City of Greenville

Planning Commission

4:00 PM March 17, 2022

**Planning Staff Report to
Greenville Planning Commission
March 11, 2022
for the March 17, 2022 Public Hearing**

PRELIMINARY PLAN

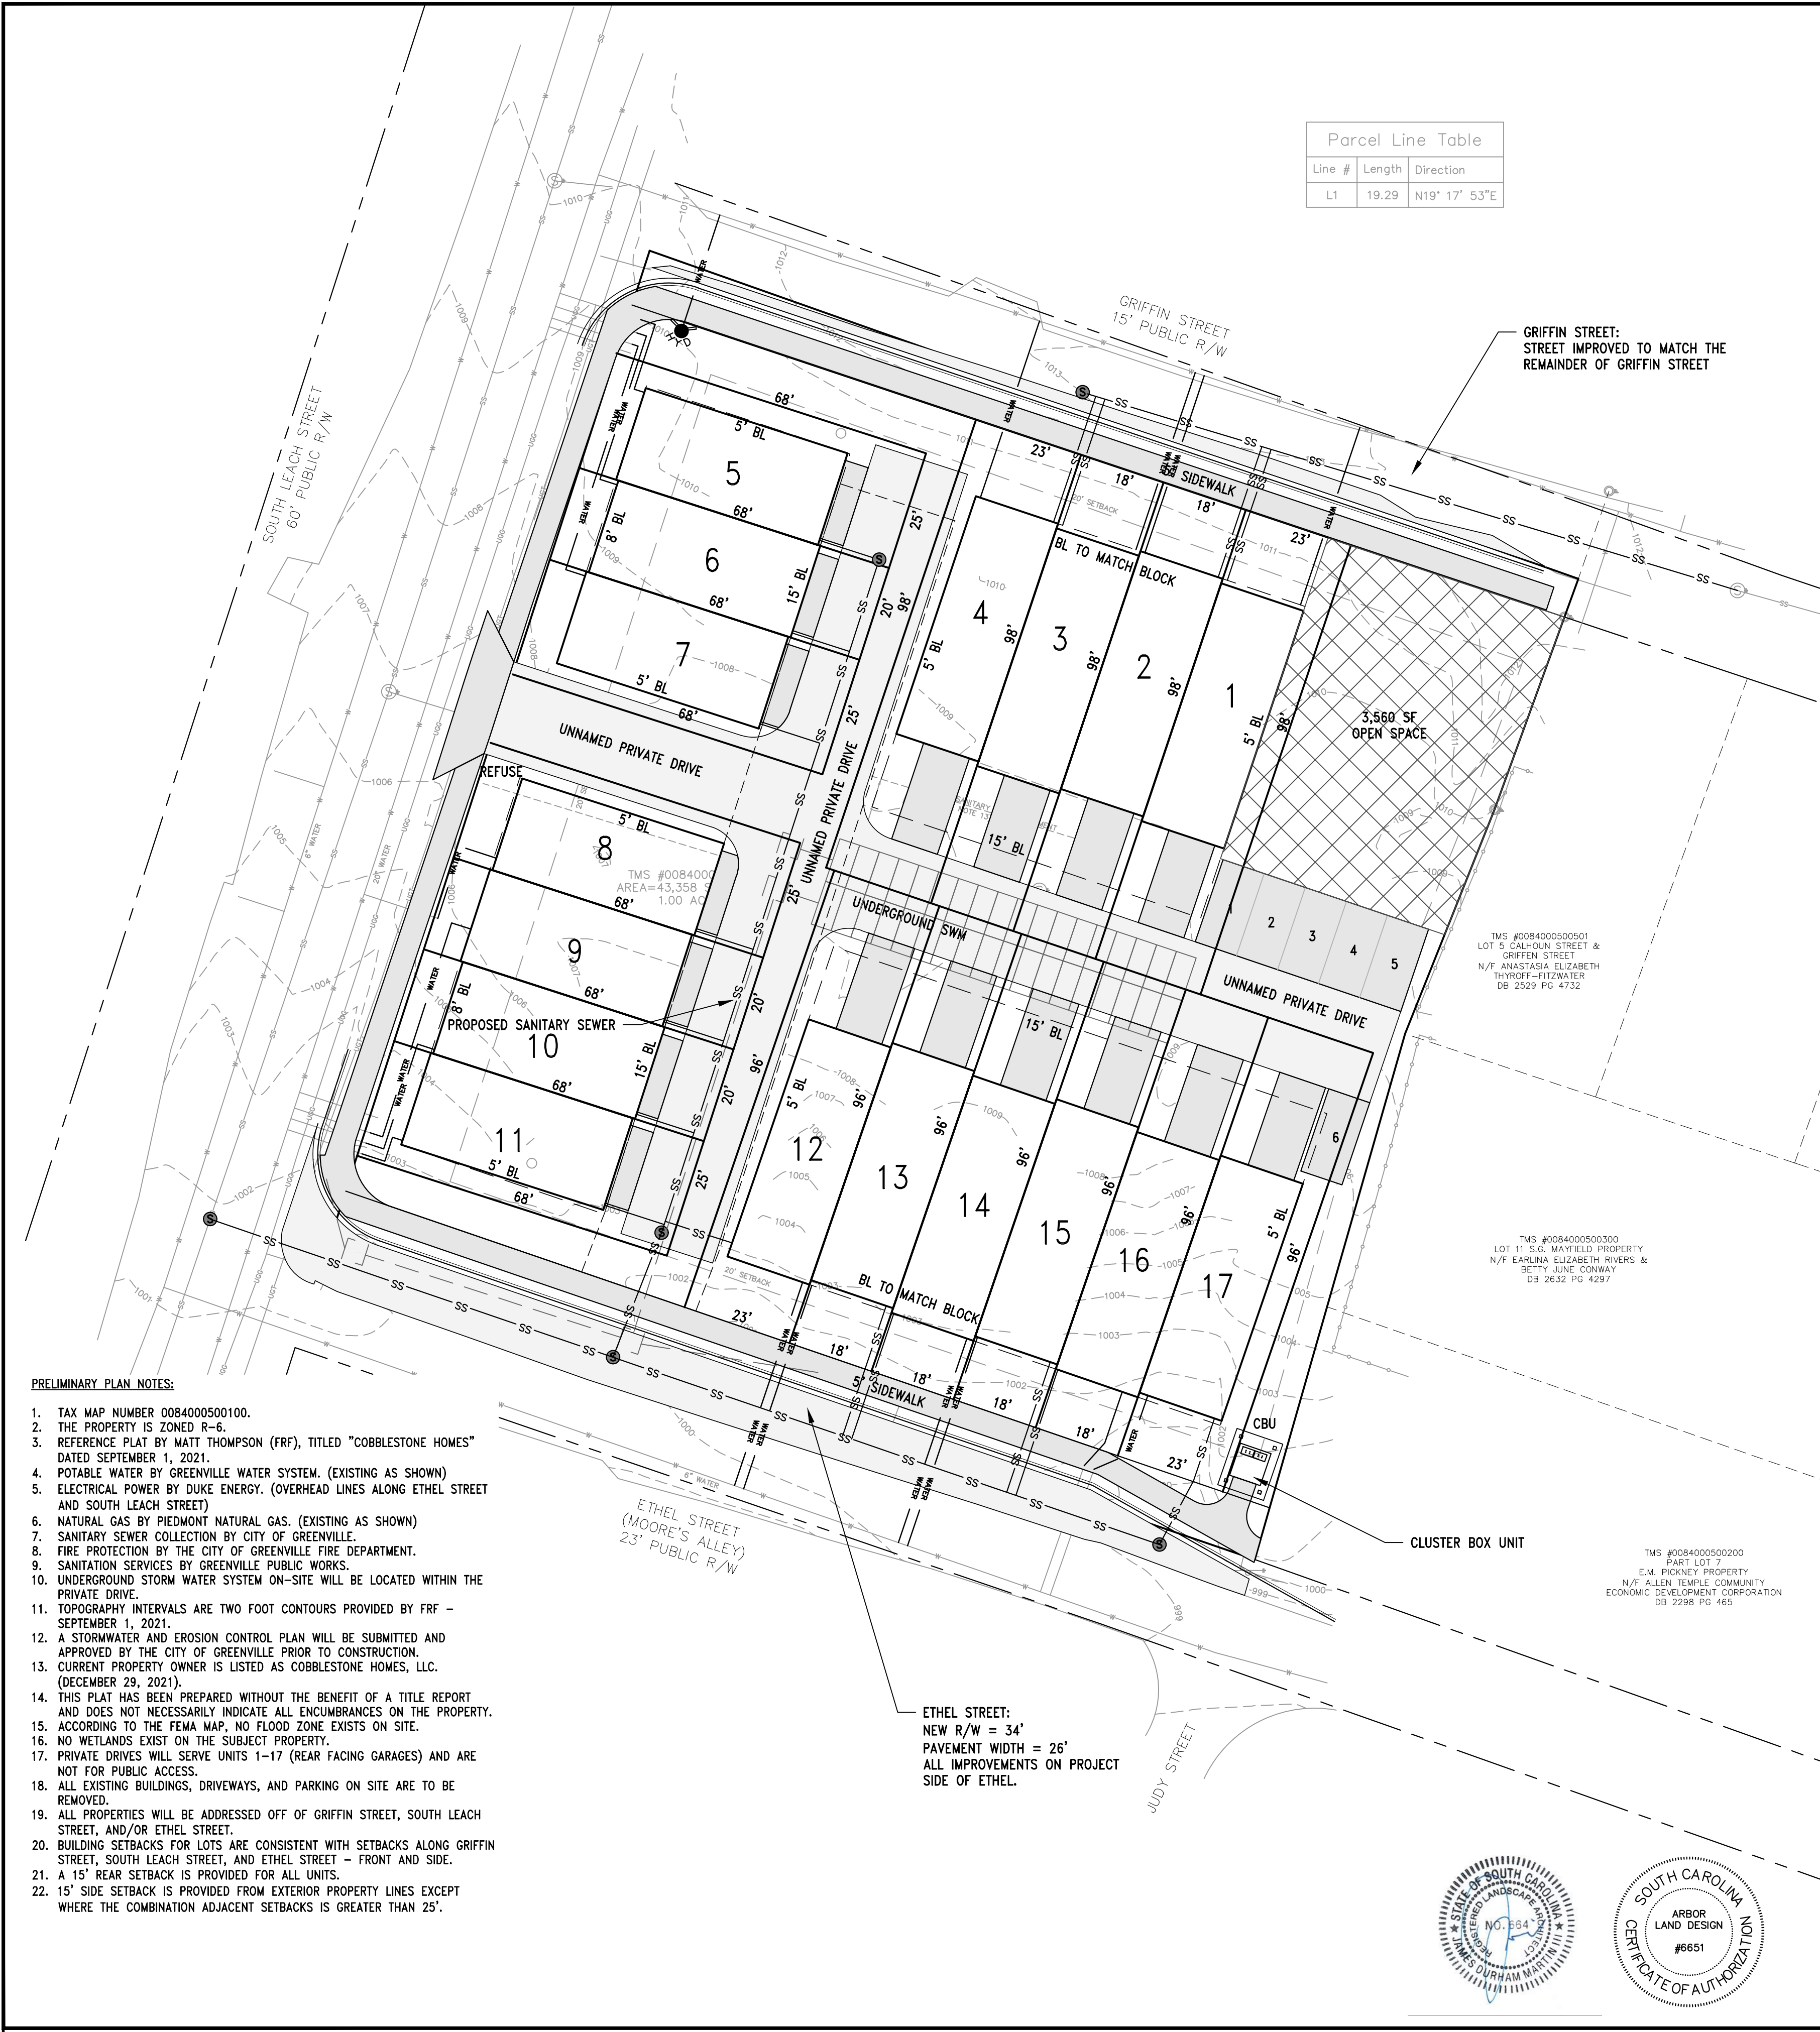
The location of units on the plan reflect compliance with minimum dimensional standards for single-family attached residences. Orientation of the front of the structures towards the existing streets, as proposed, is desirable and consistent with standards for attached residential units. Corner units should incorporate a design that presents similar architectural features on the secondary frontage as is required on the front of the units, specifically relevant to units on Lots 5 and 11.

- 6) The sidewalk on Ethel Street and Griffin Street will need to be five-foot sidewalk and two-foot curb lawn.
- 7) City Driveway Apron - If a driveway is to be constructed the driveway apron must meet the requirements of the City of Greenville's *Residential/Commercial* Driveway Detail as shown in standard drawing 13.01/13.02.

**WETLANDS
& BUFFER
EXHIBIT**

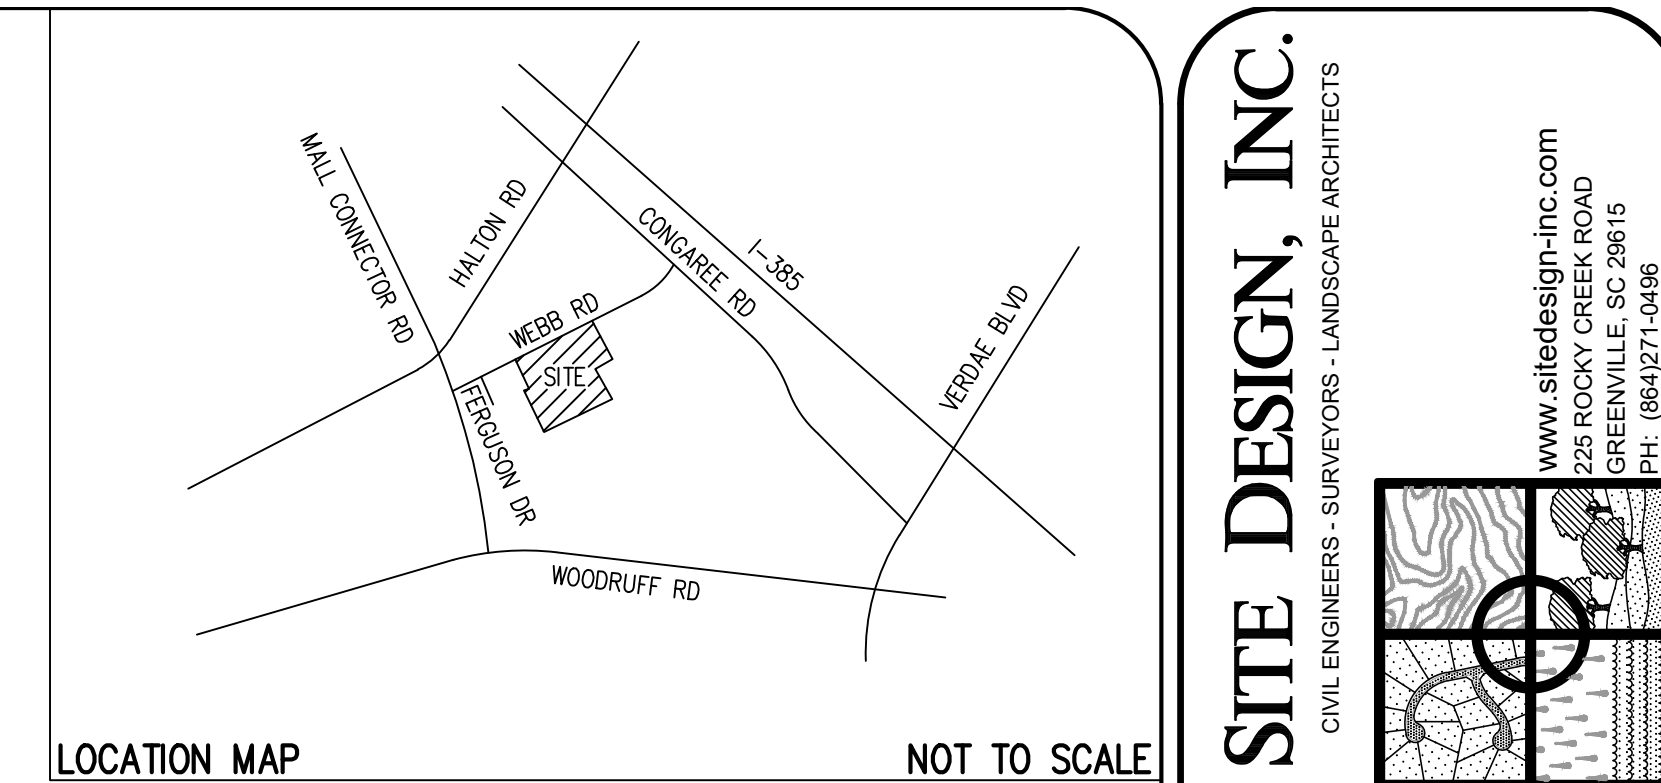
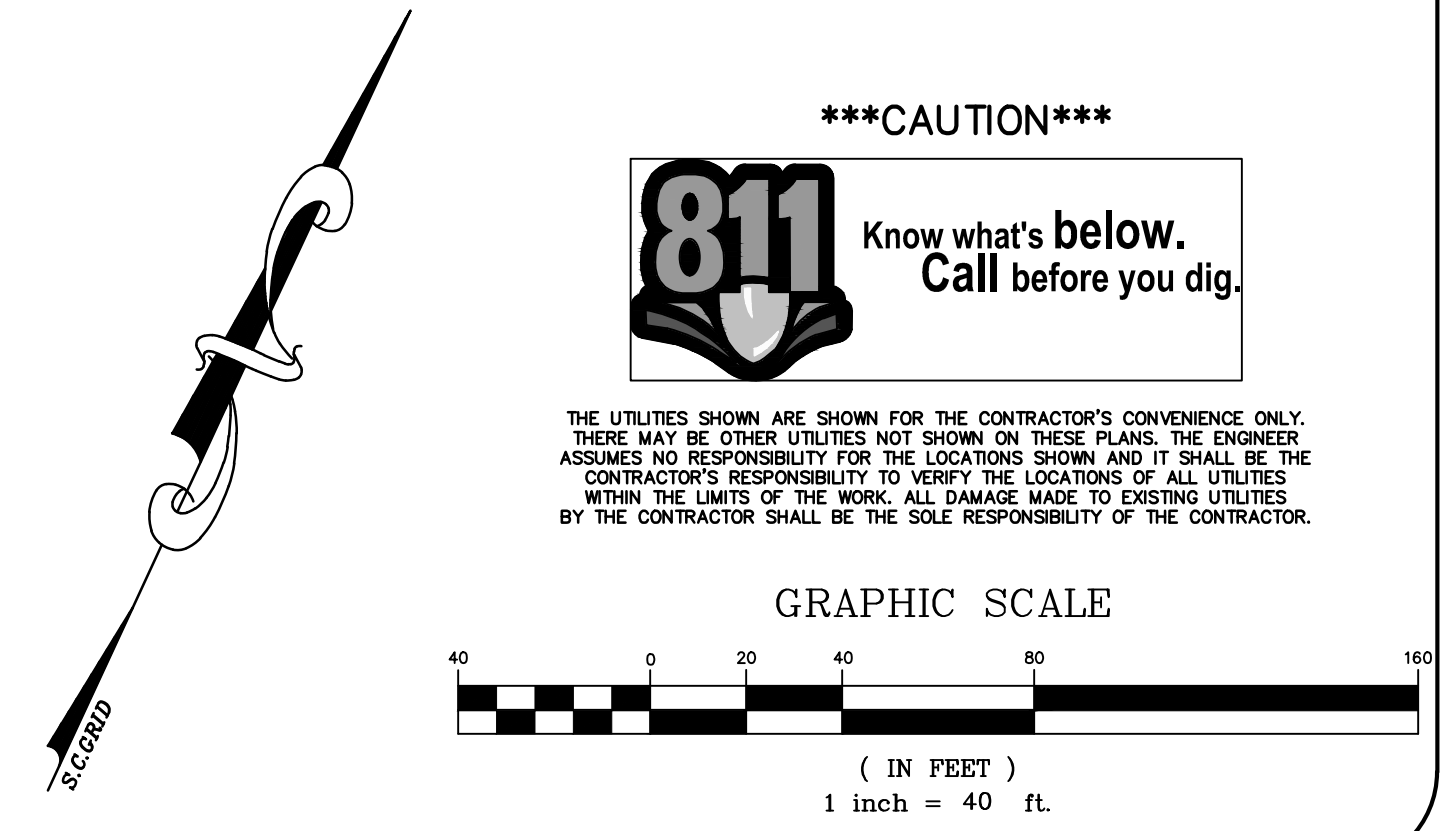
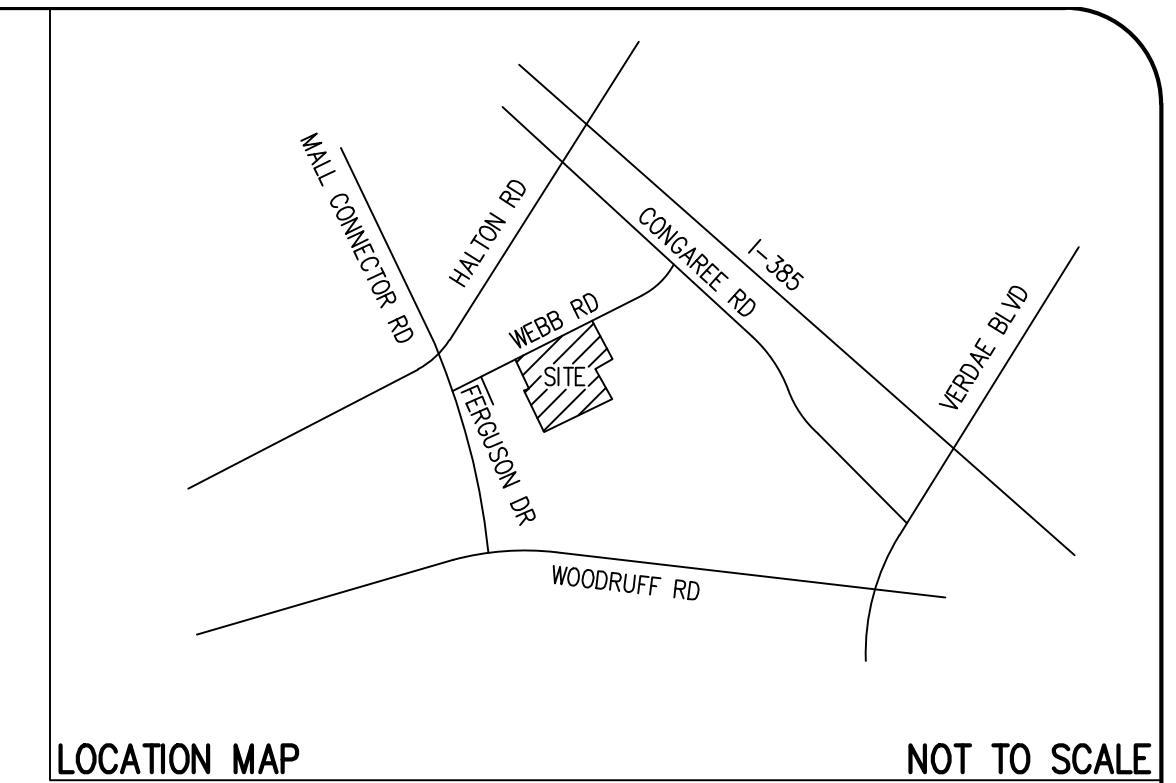
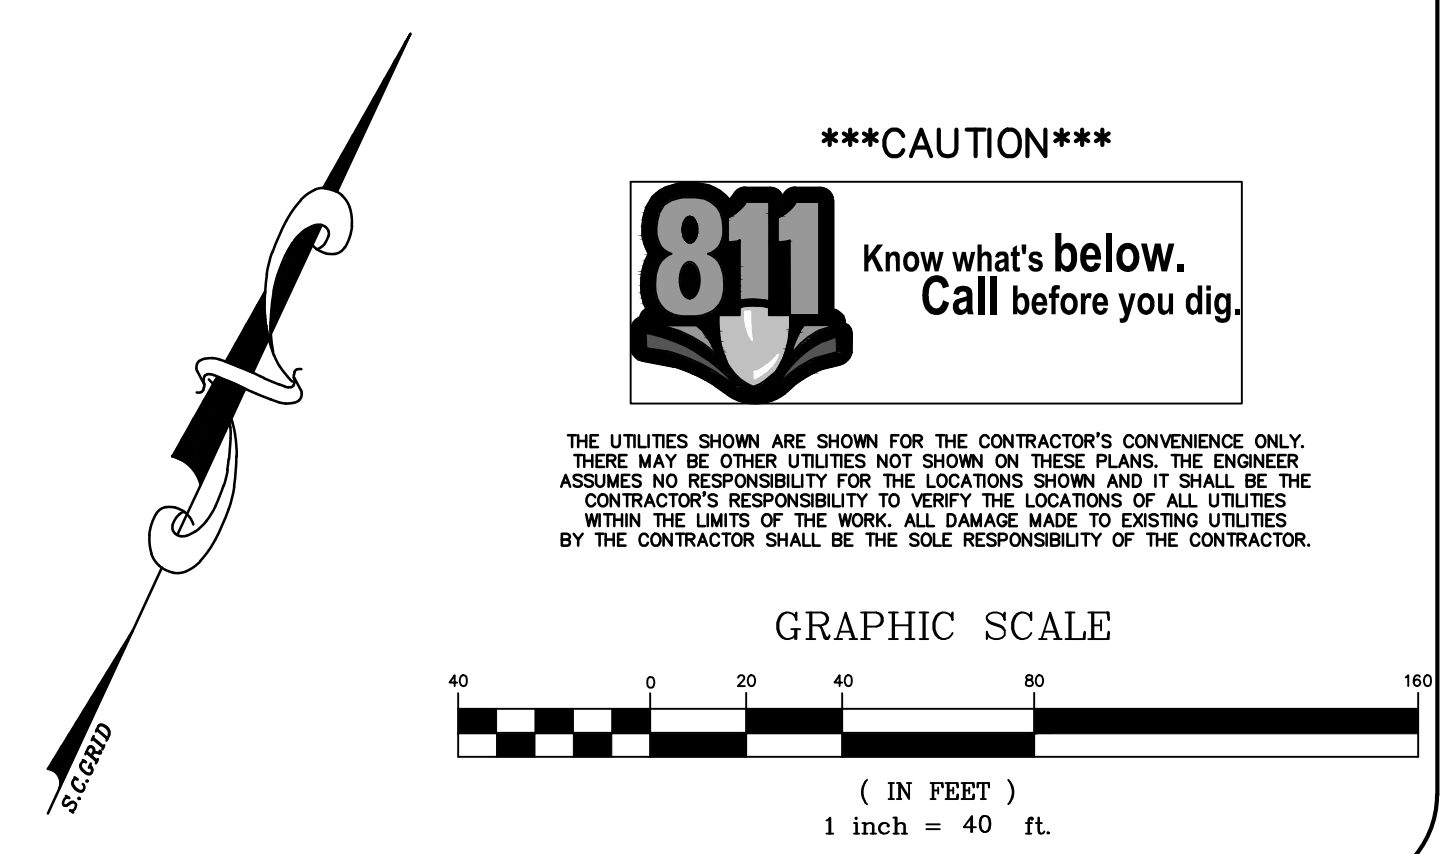
Staff response: The applicant's stated reason for the stormwater variance request is primarily related to the buffer areas and the need to provide access to the rear of the site.

Staff response: The applicant is only asking for encroachment into the required minimum buffer width.

Staff response: The configuration of the buffer areas inhibit access to the rear of the site.

Staff response: Wetland impacts are minimized with the proposed layout.

The request is for a reduction of the buffer width and the elimination of the
buffer zone in specific areas as shown on the attached plan sheet.
